Access Compliance Report

Public Rights-of-Way

Intersection ID: 31204	Main Street: GOODLOE_DR	Cross Street: SANDPINES_LN	Location: S
ADA ID: 88EED95A1D17	Ramp Type: PerpDiag	Initial Pass/Fail: Fail	Overall Compliance: No
Codes/Mitigation Info/Possible Solution		Field Measurements/Component Compliance	
Severity Score: 10

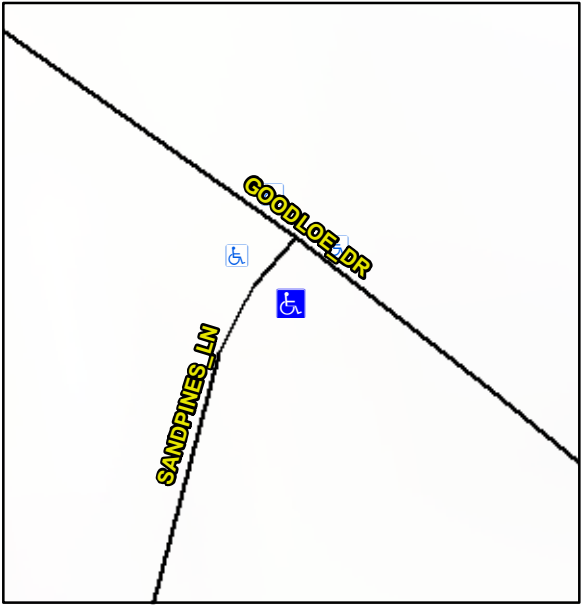
Possible Solutions:		Compliance		Description		Data	Compliance	Description	Data
	Remove & Replace Curb Ramp With Two New Directional Ramps or Equivalent.		N/A		Ramp Length (in)		48.0	Yes	Ramp Slope (%)	7.6
<p>Surveyor Notes:</p> <p>N/A</p> <p>PROW/ADA:</p> <p>Not Found, R304.5.1, R304.5.3</p>			No		Ramp Width (in)		47.0	No	Ramp XSlope (%)	4.0
			N/A		Flare Type LT		N/A	N/A	Flare Type RT	N/A
			N/A		Flare Slope LT (%)		N/A	N/A	Flare Slope RT (%)	N/A
			N/A		Flare Traversable LT?		N/A	N/A	Flare Traversable RT?	N/A
			N/A		Landing Length (in)		N/A	N/A	DWS Provided?	N/A
			N/A		Landing Width (in)		N/A	N/A	DWS Contrast?	N/A
			N/A		Landing Slope (%)		N/A	N/A	DWS Length (in)	N/A
			N/A		Landing X Slope (%)		N/A	N/A	DWS Full Width?	N/A
			N/A		Landing Curb? (Y/N)		N/A	N/A	DWS Offset (in)	N/A
			N/A		Shared Landing?		N/A			
			N/A		Gutter Ponding?		N/A	N/A	Gutter Slope (%)	N/A
			N/A		Gutter Lip Ht (in)		N/A	N/A	Gutter X Slope (%)	N/A

N/A		Painted X Walk1?		No	N/A	Painted X Walk2?	No
					X Walk 1 Direction	To NE			X Walk 2 Direction	To NW
			N/A		X Walk 1 Width (in)		N/A	N/A	X Walk 2 Width (in)	N/A
					X Walk 1 Slope (%)		1.2		X Walk 2 Slope (%)	1.5
					X Walk 1 X Slope (%)		2.7		X Walk 2 X Slope (%)	3.4
			N/A		Ramp inside XWalk1?		N/A	N/A	Ramp inside XWalk2?	N/A
					Road Slope (%)		1.2	N/A	Clear Space?	N/A
					Road X Slope (%)		8.0	N/A	Clear Space to XWalk (in)	N/A
			N/A		Any Obstructions?		N/A	N/A	Storm Grate/Utility Hazard?	N/A
					Obstruction Type				Storm Grate/Utility Type	
								N/A		N/A
								Yes	Surface Condition? (G/P)	Good
